PLAN AND PROFILE FOR THE IMPROVEMENT OF STORM DRAIN FOR

TRACT NO. 19411-1,2,3

TRACT NO. 19411-1,2,3
COUNTY OF RIVERSIDE
STORM DRAIN IMPROVEMENT PLAN
TITLE SHEET

TRACT NO. 19411-1,2,3
COUNTY OF RIVERSIDE
STORM DRAIN IMPROVEMENT PLAN
DETAIL SHEET

PLAN

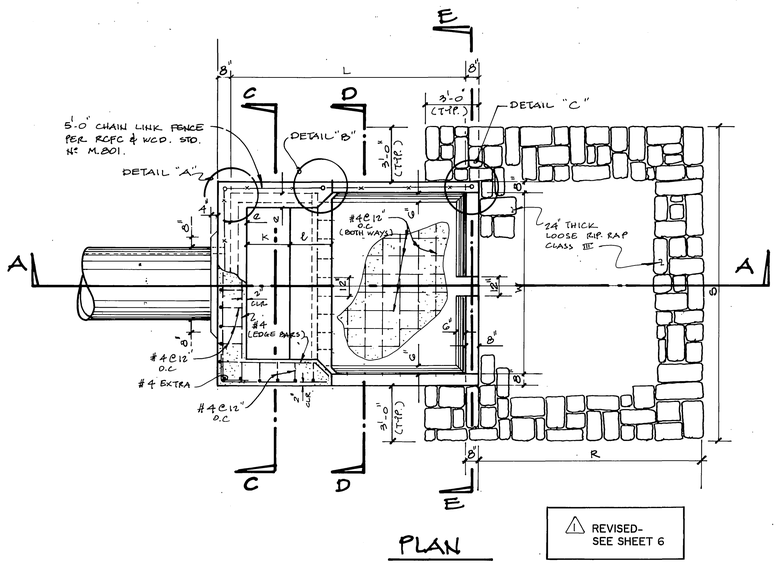
⚠ REVISED- SEE SHEET 6

SECTION "A-A"

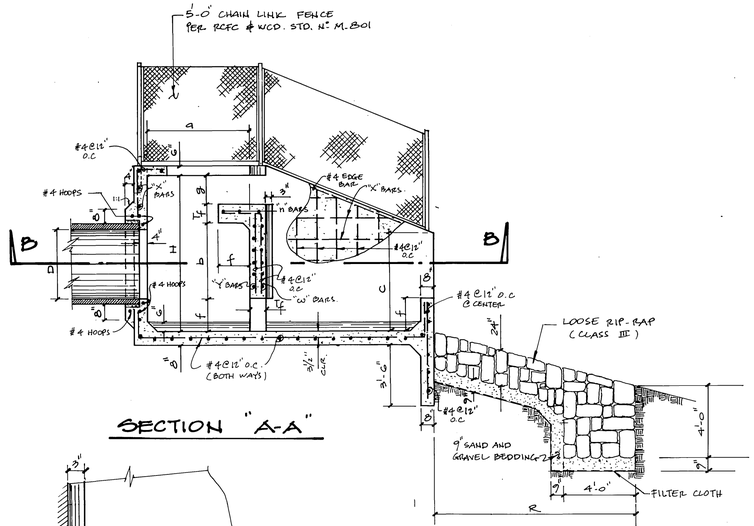
⚠ REVISED- SEE SHEET 6
